From: [Hoque, Shamsul](#)
To: [Norfolk Vanguard](#)
Cc: rebecca.sherwood@vattenfall.com; [Andrew Ross](#)
Subject: BN07 SACTN Review with drawings
Date: 10 April 2019 12:36:51
Attachments: [BN07 SACTN Review \(Issued\).pdf](#)
[Appendix F LR mentioned in BN07.pdf](#)

Project:	Highways England Spatial Planning Arrangement 2016-2020	Job No:	60600479/DN052.004
Subject:	Norfolk Vanguard Wind Farm - Substations Access Clarifications Technical Note		
Prepared by:	Andrew Cuthbert	Date:	4th April 2019
Checked by:	Andrew Beard	Date:	4th April 2019
Verified by:	John Alderman	Date:	5th April 2019
Approved by:	Andrew Cuthbert	Date:	5th April 2019

1. This Briefing Note (BN07) comprises a review of the '**A47 Substation Access Clarification Technical Note**' (SACTN), dated 12th March 2019, prepared by Royal Haskoning DHV (RHDHV) in respect of the access arrangements required to serve the existing and proposed substations adjacent to the A47 Trunk Road at Necton, to the west of Dereham.

A47 NATIONAL GRID SUBSTATION
ACCESS A (AC181)
CONCEPT DRAWING
(LEFT TURN IN / LEFT TURN OUT)

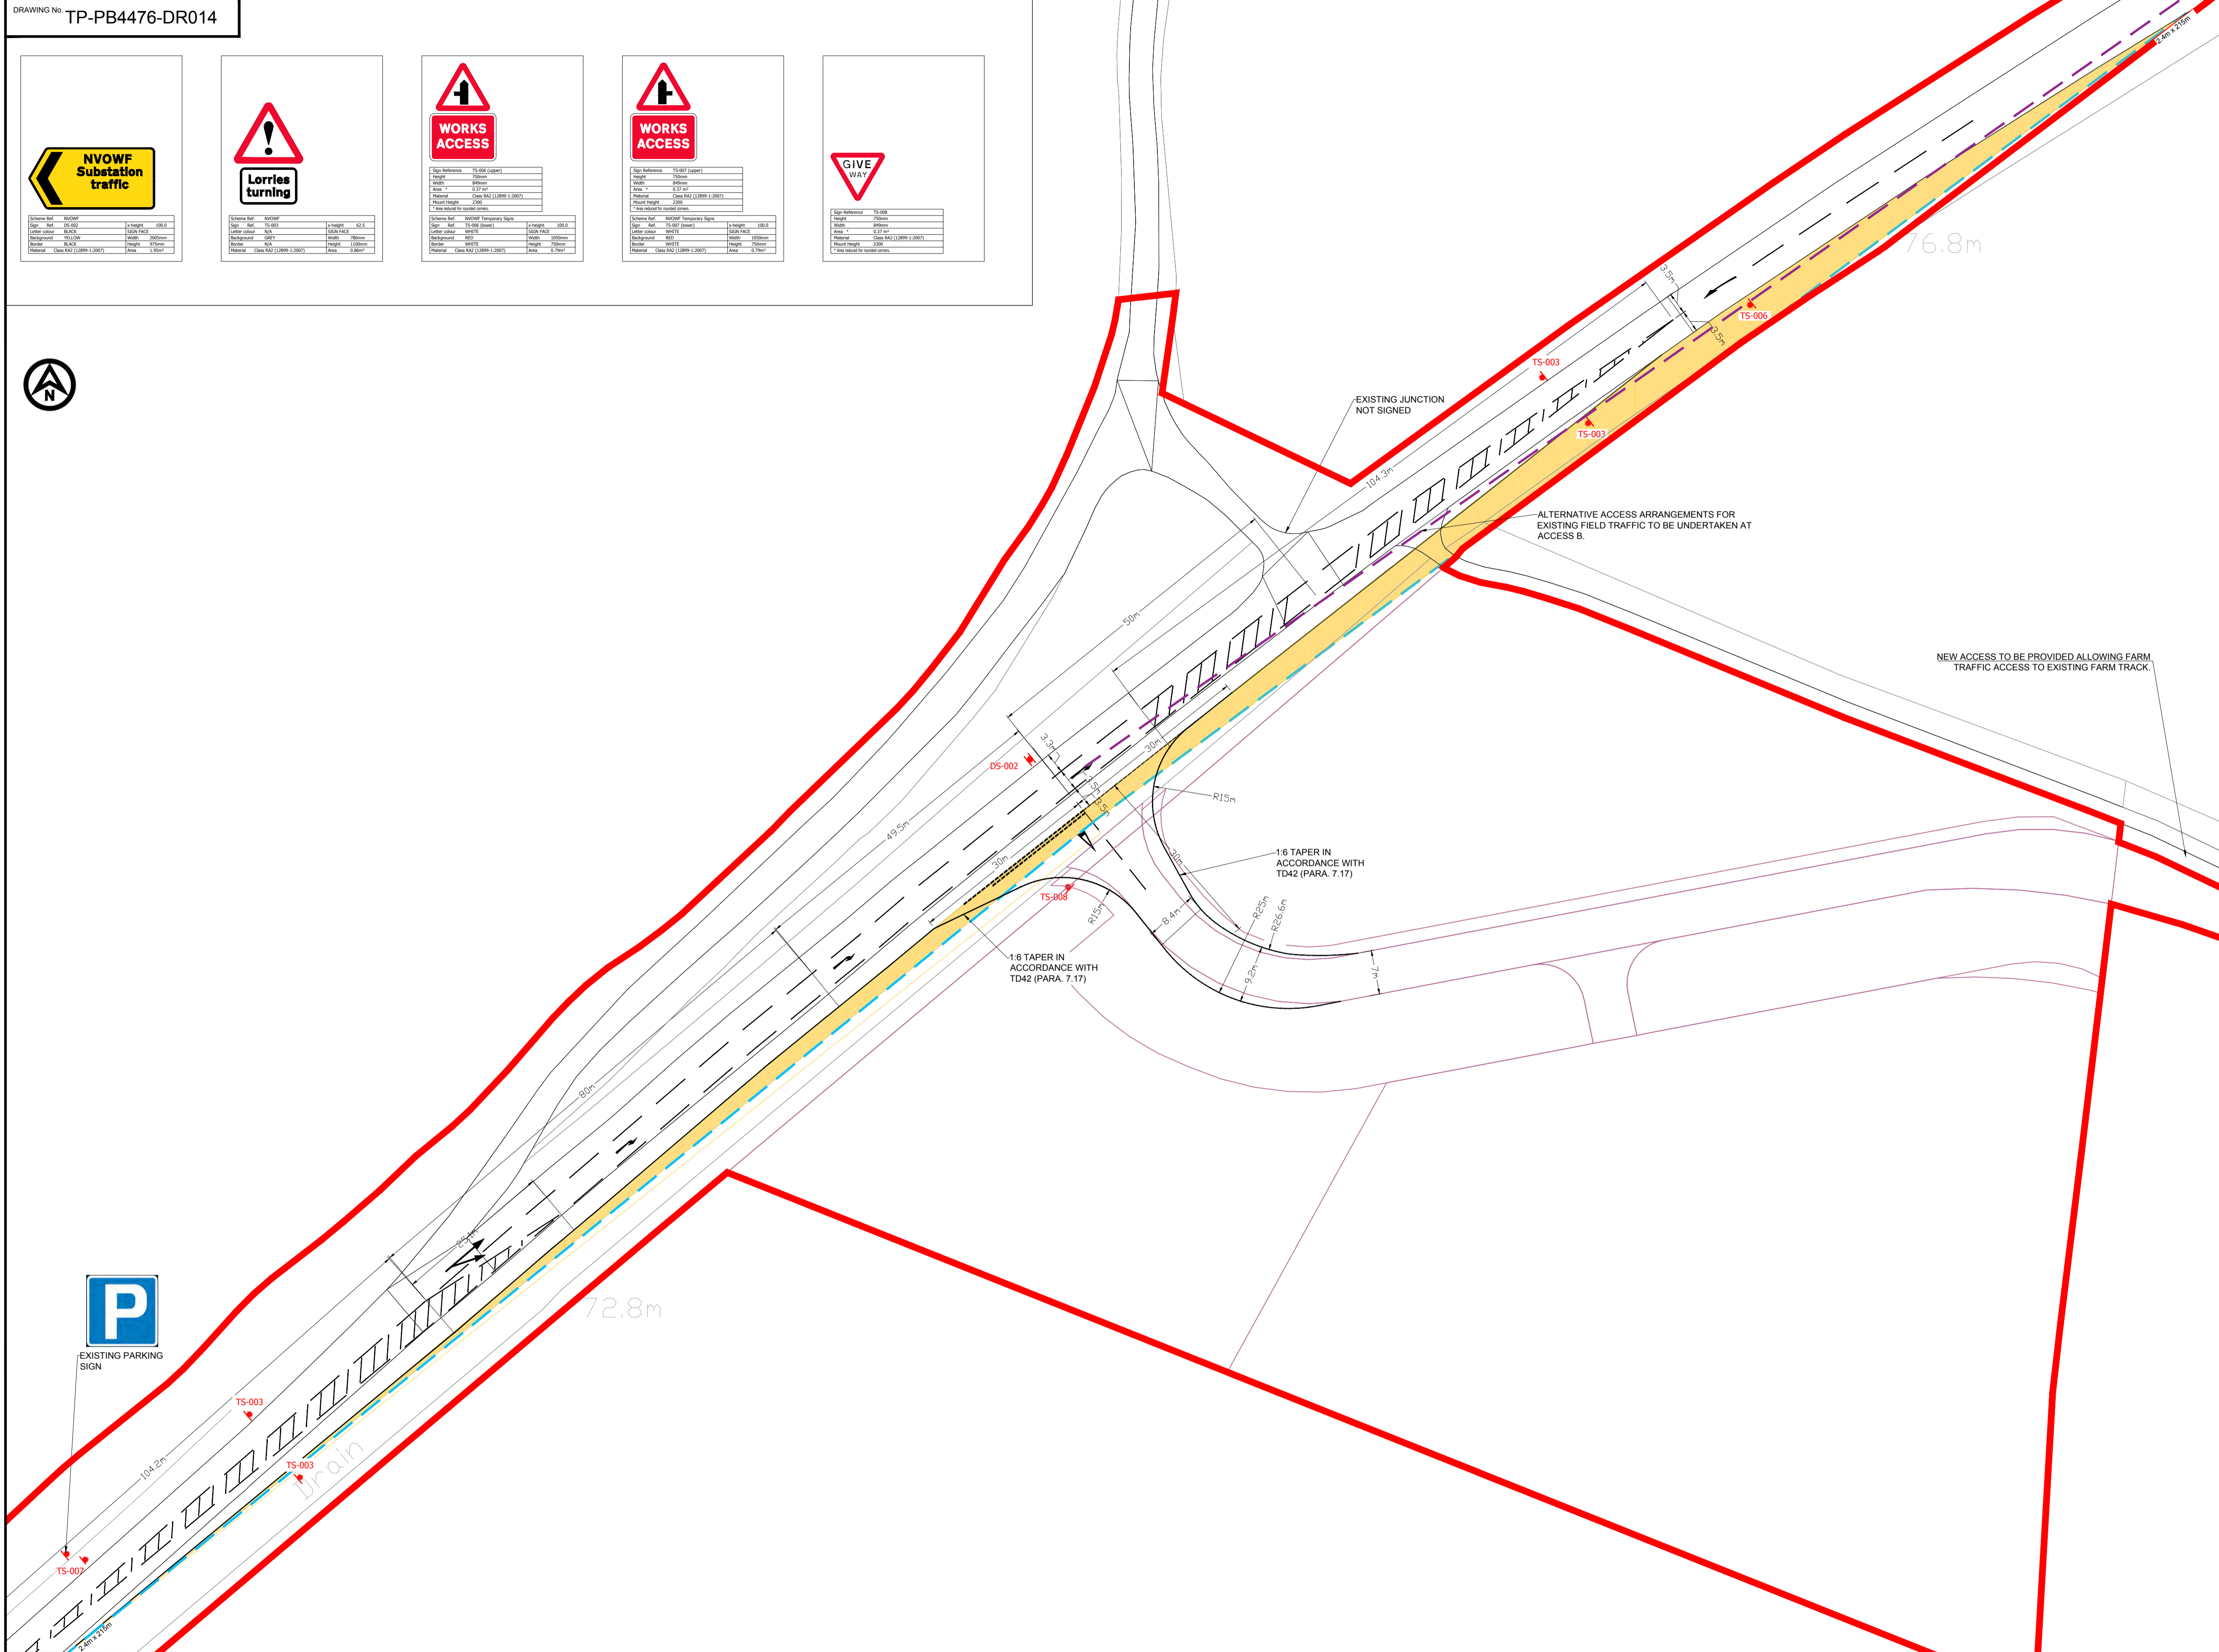
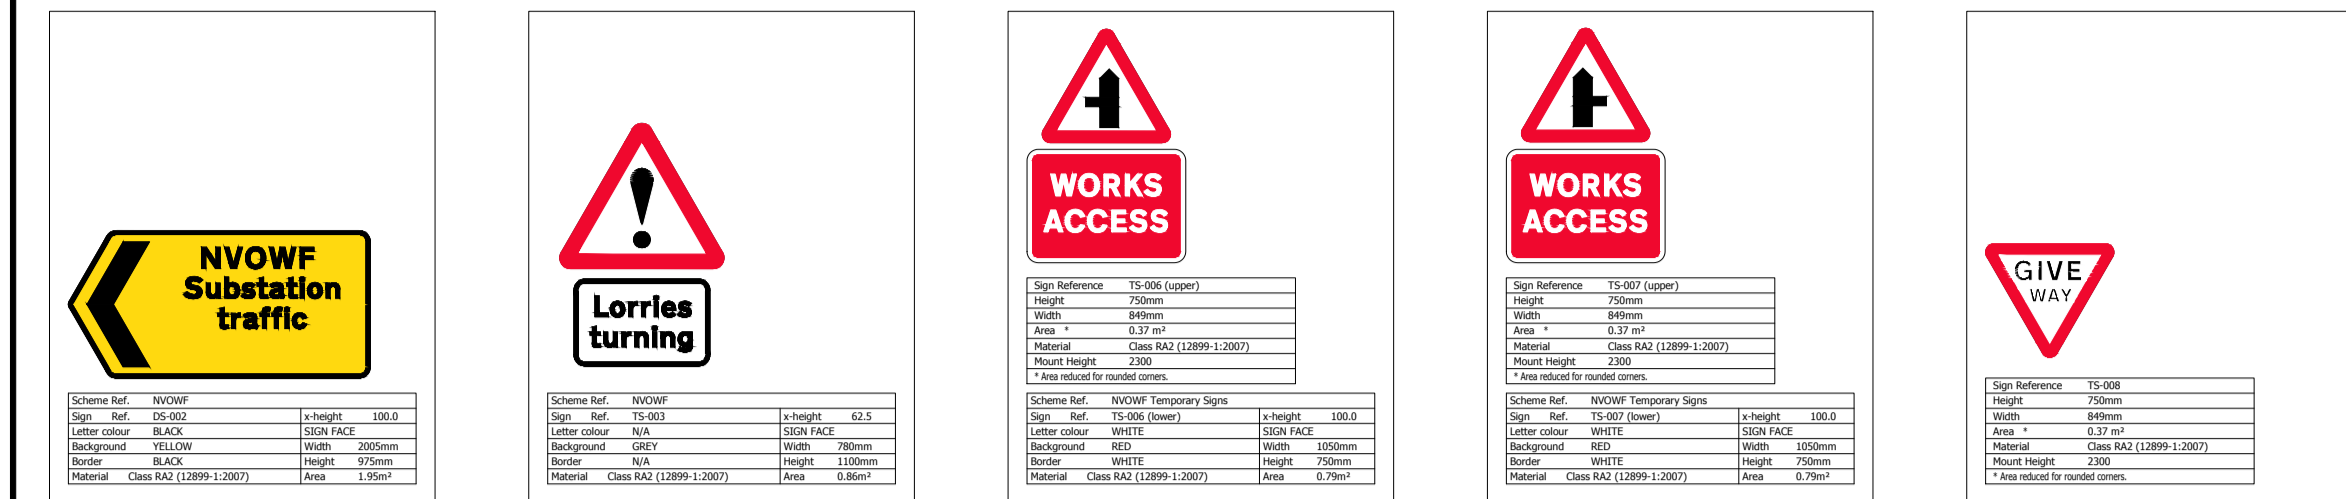
Item	Access A	Access B	Access D1
Drawing numbers	PB4476-DR012/F1.0 PB4476-DR017/F1.0 PB4476-DR018/F1.0	PB4476-DR014/F1.0 PB4476-DR021/F1.0 PB4476-DR022/F1.0	PB4476-DR015/F1.0 PB4476-DR023/F1.0 PB4476-DR024/F1.0
Junction type	Simple priority junction, to be limited to left-in, left-out operation	Ghost island priority junction	Simple priority junction, to be limited to left-in, left-out operation
Peak level of traffic use	100 light vehs/day; 68 HGV/ day; 50 light vehs/ peak hr; 7 HGV/ peak hr.	180 light vehs /day; 150 HGV/ day; 90 light vehs / peak hr; 16 HGV/ peak hr.	4 light vehs /day; 20 HGV/ day; 50 light vehs / peak hr; 7 HGV/ peak hr.
Duration of use	86 weeks in total, of which 16 weeks at the peak level of use	At least 100 weeks in total, of which 24 weeks at peak level of use	2 individual weeks of use, separated by a gap of 4-6 months
Design speed of main road adopted	100 km/hr	100 km/hr	60 km/hr (*)

Corner radii	15m	15m	15m
Exit tapers	25m @ 1:10	30m @ 1:6	25m @ 1:10
Visibility splays (assumes existing vegetation to be cleared/maintained as required) <u>NB evidence still to be submitted that these can be proven in the vertical plane</u>	4.5 x 215m	4.5 x 215m (L) 2.4 x 215m (R)	4.5 x 90m (*)
Swept path plots	These all show that HGVs can complete their turns without clipping kerb lines, and without encroaching on the wrong side of the A47		
	An HGV could enter the minor arm and stand clear of the A47 running lane whilst another HGV emerges from the minor arm	HGVs can enter and leave simultaneously without their swept paths conflicting.	An HGV could enter the minor arm and stand clear of the A47 running lane whilst another HGV emerges from the minor arm

- The layouts shown on these drawings appear to have taken on board all the issues raised in AECOM Briefing Notes 04 and 06 and, with one exception, appear to meet in full the design requirements of DMRB. The exception is that the visibility to the right out of access point B can only be achieved from a position 2.4m back from the give way line. DMRB design standard TD42 permits a relaxation to 4.5m in difficult circumstances for lightly trafficked simple junctions and to 2.4m in exceptionally difficult circumstances.

13. On that basis, the layouts currently offered for access points A, B and D1 appear satisfactory, subject to:
- visibility splays being cleared of foliage;
 - visibility being proven in the vertical plane;
 - the implementation of the traffic management measures proposed; and
 - the carrying out of Stage 1 and 2 Road Safety Audits.
